PRODUCTION INSTRUCTIONS

MAIN CONTROLLER PCBA

Date: 10-7-2020
Revision: 1.0
Author: Tony Little
Product: Electric Skateboard
Company: Globe Brand

3 PRODUCTION BOM CHANGES

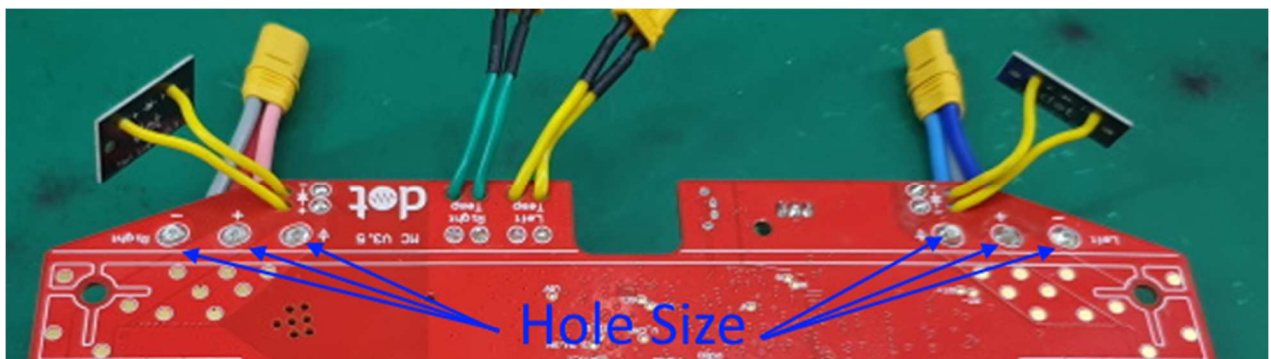
Change R26 - (previously 47kohm)

43.5k Ohm $\pm 1\%$ 0.063W, 1/16W Chip Resistor 0402 (1005 Metric)

Yageo RC0402FR-0745K3L

Change R50 – (previously 0.01ohm)

5mOhms $\pm 2\%$ 0.75W, 3/4W Chip Resistor 1206 (3216 Metric)

Susumu KRL1632E-M-R005-G-T5

5.1 CN12, USB CONNECTOR SOLDER

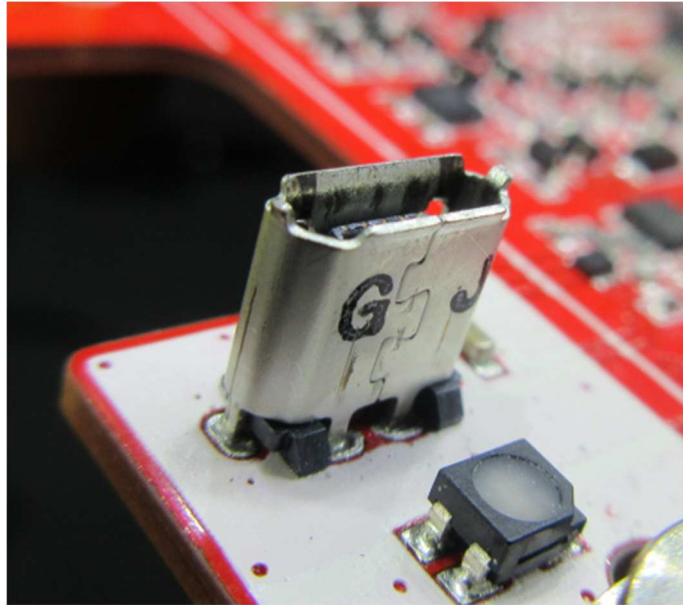
The solder fill for the USB chassis through hole mounting is insufficient. USB connector retention is less than required.

5.2 CAPACITORS

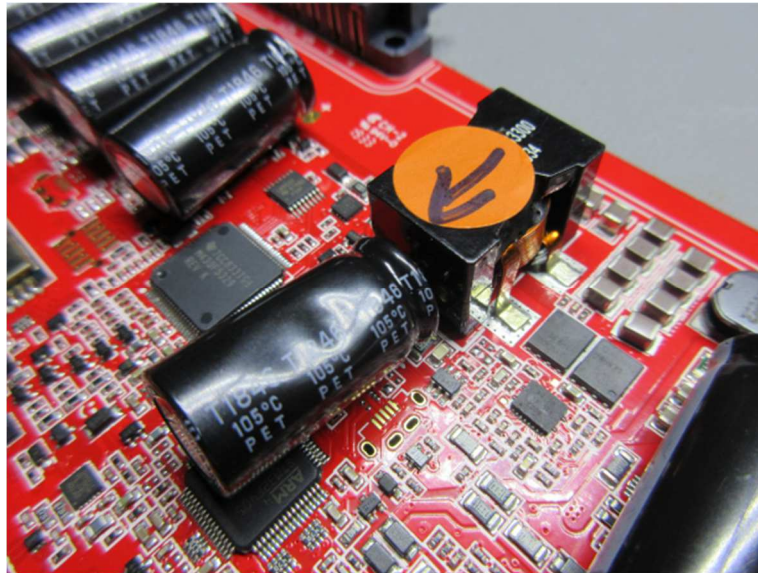
Ensure capacitor damaged is avoided.

5.3 INDUCTOR L3

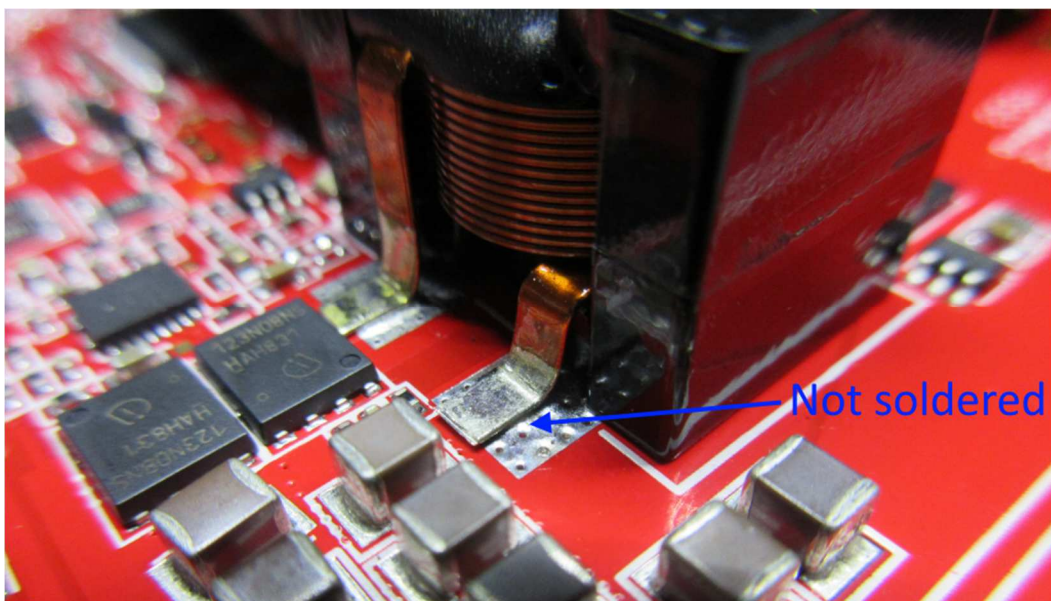
Large surface mount inductor requires visual inspection to ensure terminals are soldered.

Example below show terminal left unsoldered.

5.4 IC2, TPS40170RGY

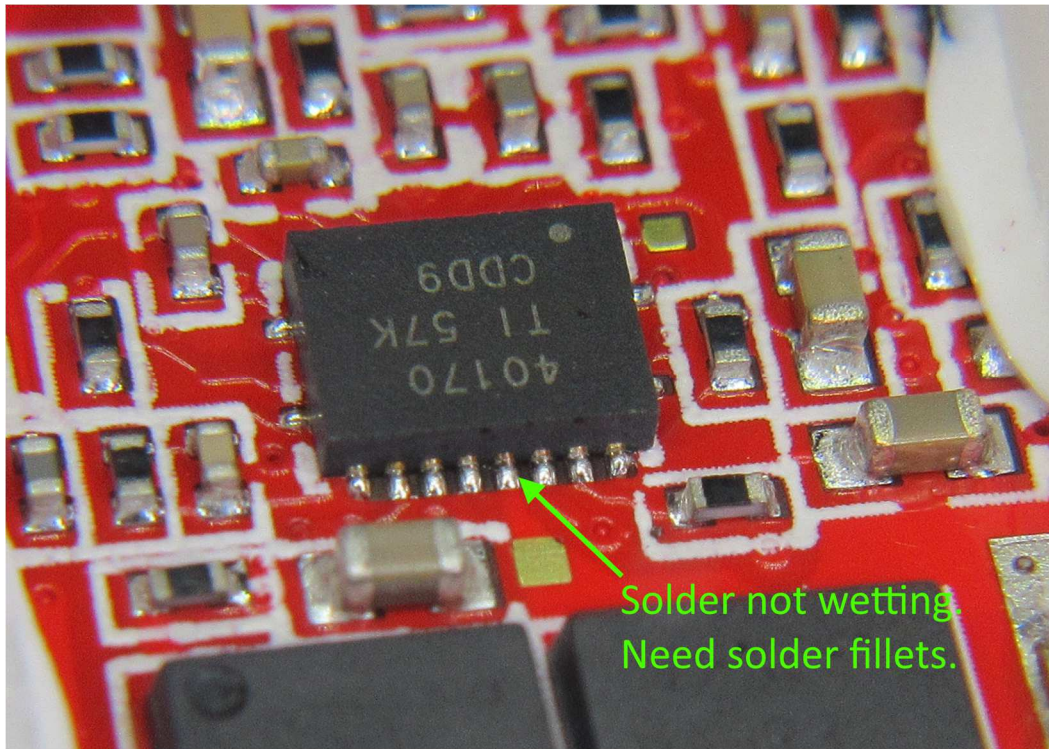
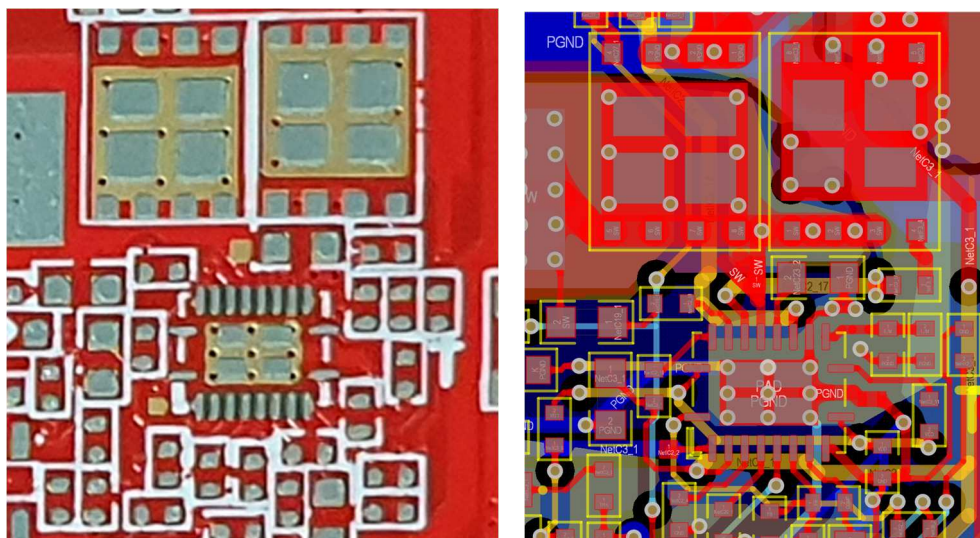
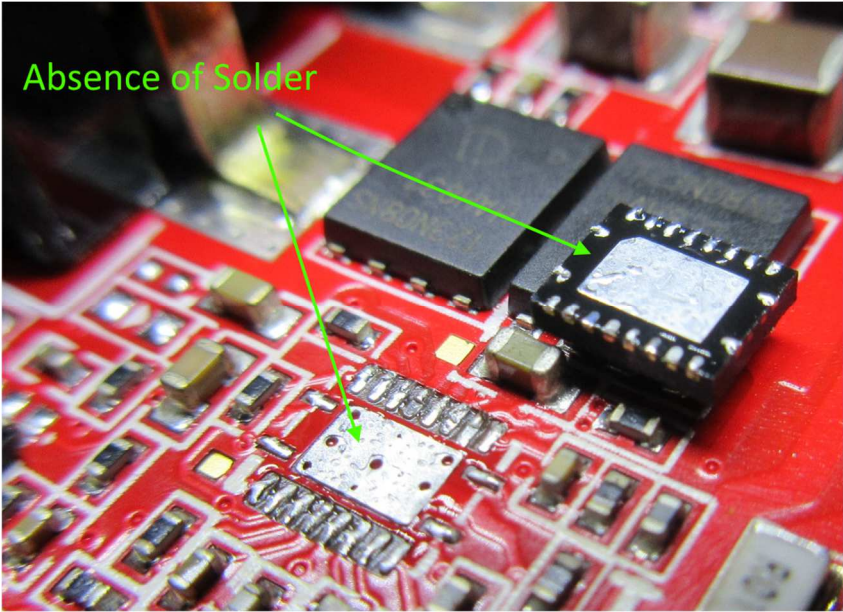
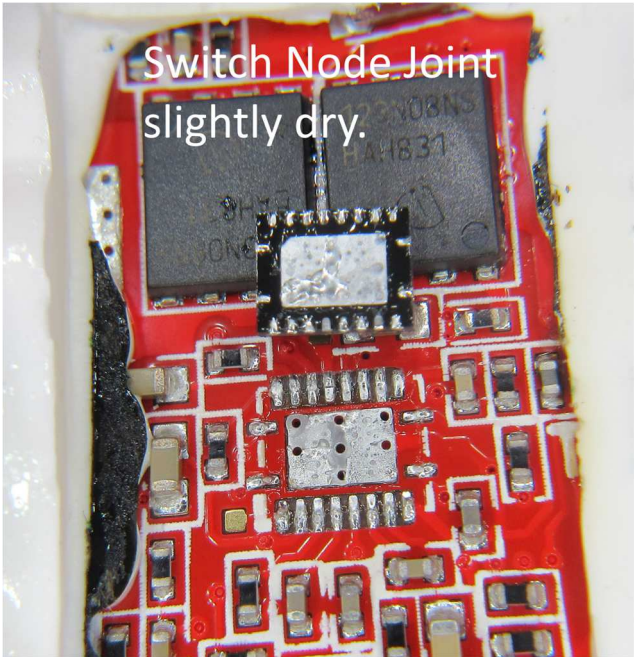
There has been a production issue associated with IC2 that has resulted in an unacceptable 6.5% failure rate. Looking for where to minimise potential failure causes. There is some concern the soldering may contribute to the failure. It is common to find this IC does not have solder wetted to form a proper fillet to the terminal sides. Moisture / shelf-life may contribute to the low solder wetting.

The solder paste design and resulting stencil printing looks good.

The 0.3mm vias may be wicking some center pad solder.

The top layer copper is 70um and the center pad has significant thermal heat sinking. Reflow infrared may have some shadow from the nearby large inductor. These both may reduce reflow heat for good wetting.

Could Union please consider how to improve IC2 solderability?

5.5 CN7, MAGNETIC CONNECTOR

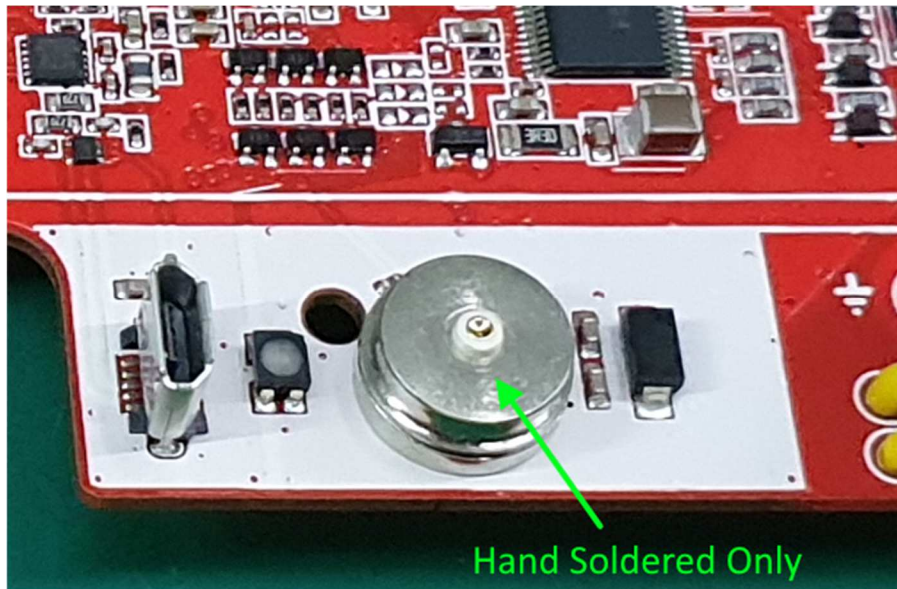
Important reminder... connector must be hand soldered after wave solder process. **Do not wave solder.** The connector is magnetic and must not be subjected to high heat.
